Title - Sujet Boiler Plant Replacement	
Solicitation No. - N° de l'invitation EZ899-170892/A	Amendment No. - N° modif. 002
Client Reference No. - N° de référence du client	Date 2016-08-17
GETS Reference No. - N° de référence de SEAG PW-\$PWY-033-7836	
File No. - N° de dossier PWY-6-39095 (033)	CCC No./N° CCC - FMS No./N° VME
Solicitation Closes - L'invitation prend fin at - à 02:00 PM on - le 2016-08-25	Time Zone Fuseau horaire Pacific Daylight Saving Time PDT
F.O.B. - F.A.B. Plant-Usine: <input type="checkbox"/> Destination: <input checked="" type="checkbox"/> Other-Autre: <input type="checkbox"/>	
Address Enquiries to: - Adresser toutes questions à: Siopongco, Philip PWY	Buyer Id - Id de l'acheteur pwy033
Telephone No. - N° de téléphone (604) 775-7691 ()	FAX No. - N° de FAX () -
Destination - of Goods, Services, and Construction: Destination - des biens, services et construction: CBSA - Huntingdon Port of Entry, Abbotsford, BC

This Amendment #002 is raised to issue Addendum #1.

The following changes in the tender documents are effective immediately. This addendum will form part of the Contract documents.

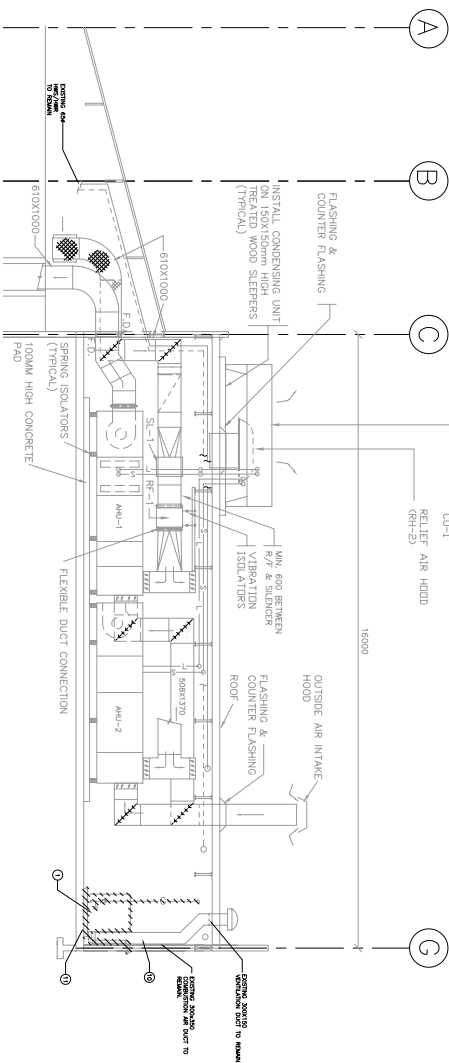
1. Revise routing of 150mm dia. power vents for boilers P-I1, and P-I2 from roof to east exterior wall (between grid line 4 and 6). Relocate the existing expansion tanks, primary-secondary header, and associated piping as per attached mechanical drawings M-102, and M-201.
2. Add key note 15 regarding existing DDC controller and control system as per attached mechanical drawing M-201.

Project No./Rev. 44 Project	3 of 4 - 08	Project File # 14-00000000
#R.078416.001	M-202 6 OF 10	3

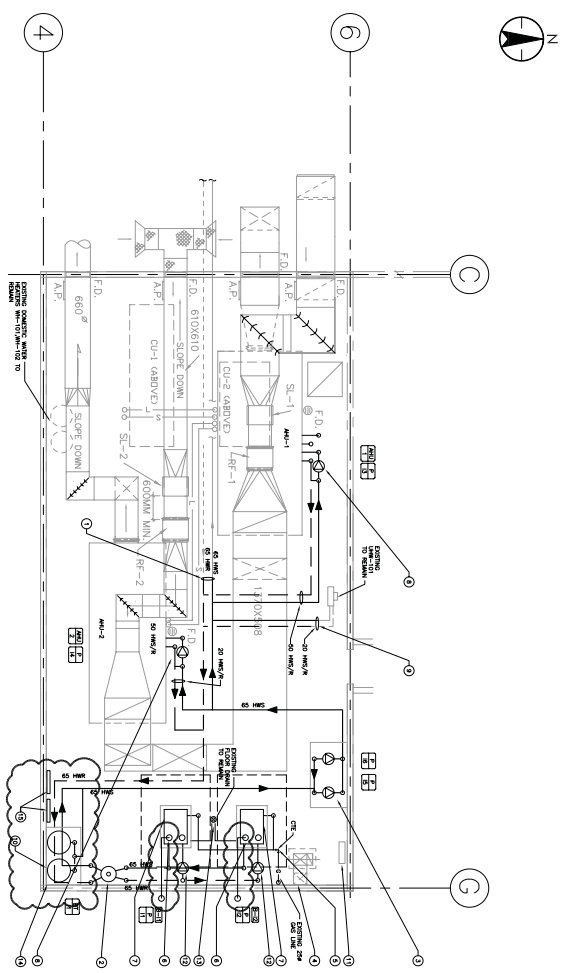
3. Revise routing of 150mm dia. power vents for boilers P-C1, and P-C2 from roof to southeast exterior wall (between grid line 2 and 3). Relocate

the boilers P-C1, and P-C2, primary secondary header, and associated piping as per attached drawing M-202.

4. Add key note 15 regarding existing interconnection heating water piping as per attached mechanical drawing M-202.
5. Add key note 16 regarding existing DDC controller and control system as per attached mechanical drawing M-202.
